Village of Bayside  
9075 N Regent Road  
Village Hall Board Room  
April 27, 2020, 6:00pm

## ARCHITECTURAL REVIEW COMMITTEE AGENDA

**NEW ROOF PLAN VIEW 1/2" = 1'-0"  
FOR REFERENCE ONLY - INSTALLATION CONTRACTOR  
TO DETERMINE APPROPRIATE FRAMING**

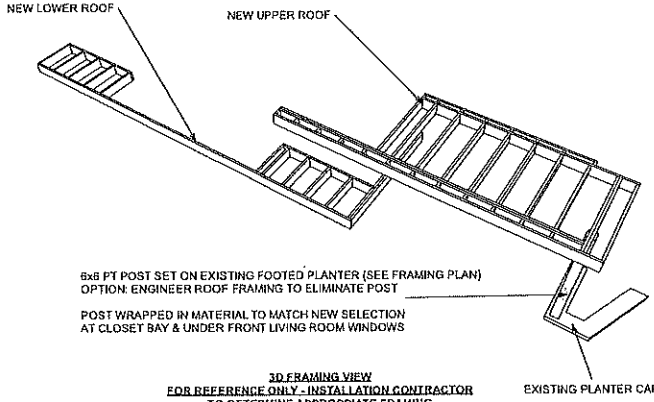
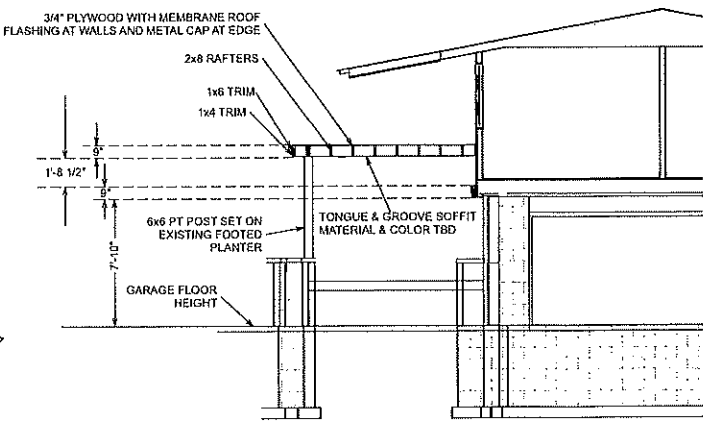
New roof will add additional loads to the cantilevered bump out wall. New and existing framing is to have adequate structural support.

**STRUCTURAL IS APPROVED AS NOTED**

Garden Shed  
Rear yard 9070 N BAYSIDE DRIVE  
Estimated cost \$2500<sup>00</sup>

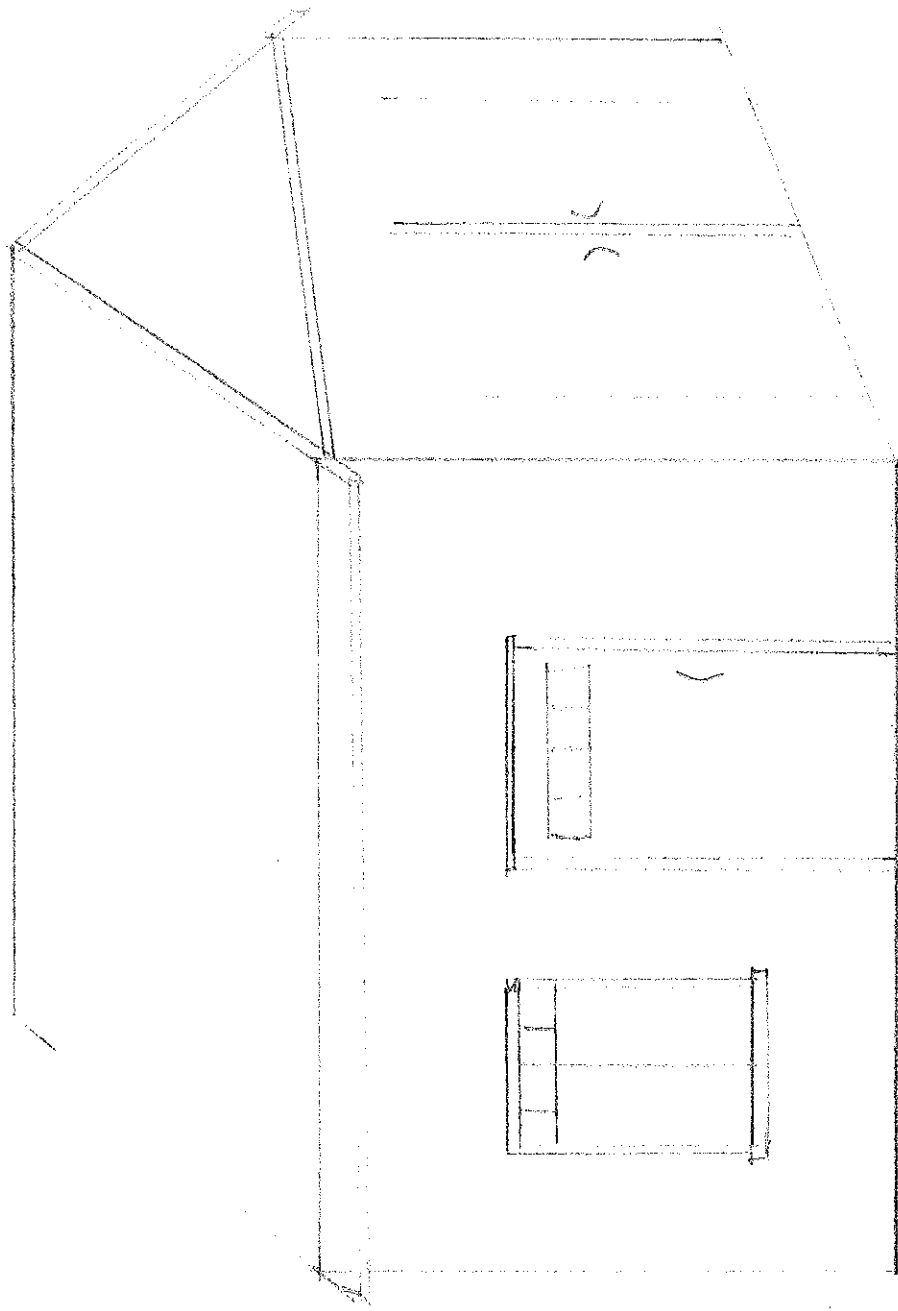
Exact dimensions are not provided for the location of the new shed. Village code section 125-91 - "C" residence district regulations requires that accessory structures be located a minimum of 10ft from both rear yard and side yard property lines. Owner is to verify 10' setbacks.

*Figure 2: Hermitage Lift Station Generator*

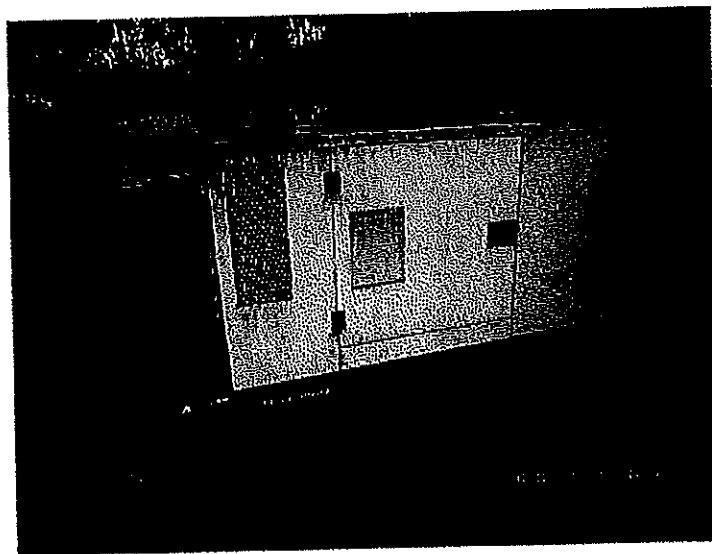
The generator at the Hermitage Lift Station is 25 years old and has reached the end of its useful life (Figure 2). Kapur recommends that the generator should be replaced. The generator located at the Baypoint Lift Station is in good condition and should be moved to this site to save replacement costs.

*Figure 3: Hermitage Lift Station Control Building*

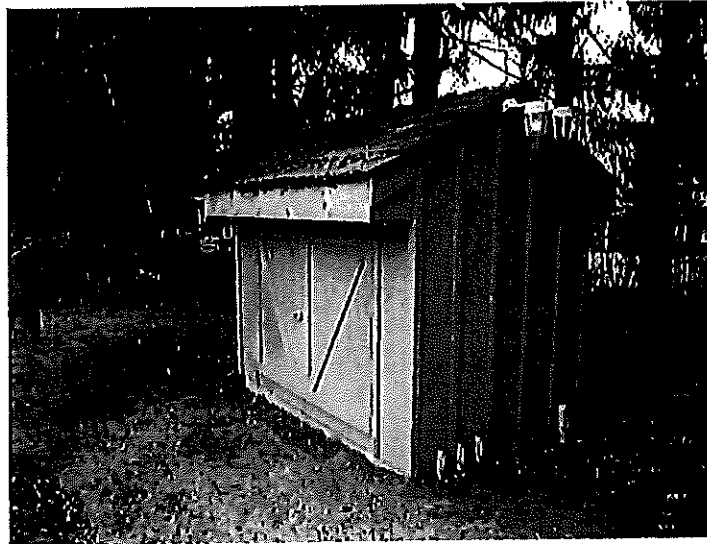
Kapur recommends that the existing control building (Figure 3) be replaced with a similar structure that is easier to access for maintenance. The existing entry to the control building is short and requires operators to crouch to enter the control building. The roof on the existing structure also needs repairs. Significant upgrades to the relocated generator would be required to store it in the

control building. Since the recommended control building does not need to house the generator, the building would have a similar footprint as the existing.

*Figure 6: Baypoint Lift Station Control Building*

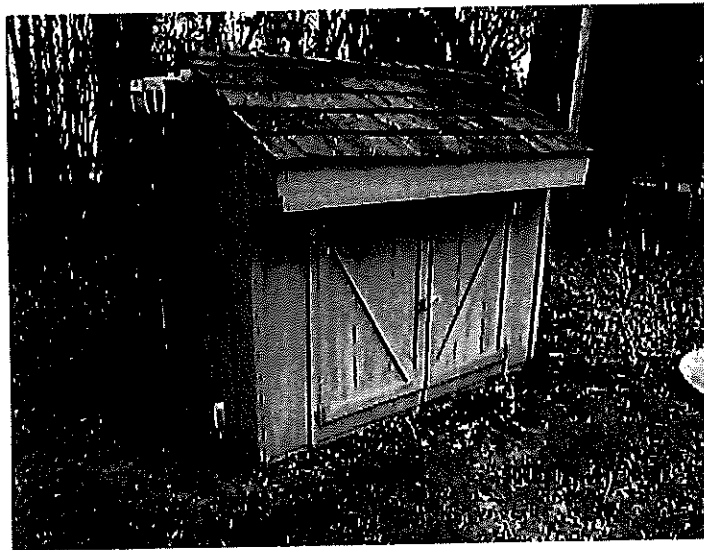
Kapur recommends that a new heated control building should be constructed to replace the existing structure (Figure 6). The new building would house the control equipment and the new generator, like the Lake Drive Lift Station. The enclosed structure will extend the life of the generator by providing protection from the elements. The structure will be located above the floodplain to prevent flooding in the control building. This has been a problem at the site in the past. Existing easements will need to be analyzed during design to ensure adequate space is available for a new structure. If space is not available, easement discussion with local property owners would be required to increase the size of the existing easement for a new building. The control building will be designed to be above flood level to eliminate the existing flooding issue at this location.
